Freedman Seating Product Updates

FW & 3PT legs

Universal Leg Design

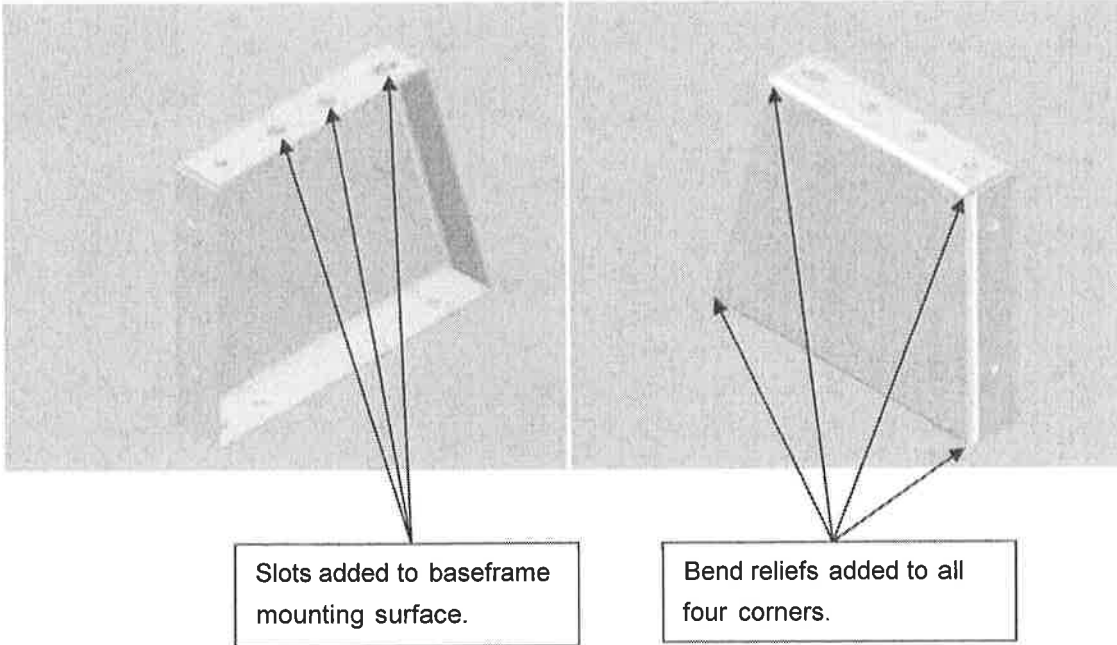
Very soon you will start seeing some slight changes in our FW and 3PT legs.

- You will see the addition of bend reliefs in the 4 corners
 - Allows for smoother forming which reduces small tears and material bulges and increases the tolerance
 - Improves the robotic welding accuracy
- Legs will now have 1 hole and 3 slots in the top surface (used to be 2 holes)
 - This makes the leg more universal across our seating products
 - Adds a little adjustability for installation
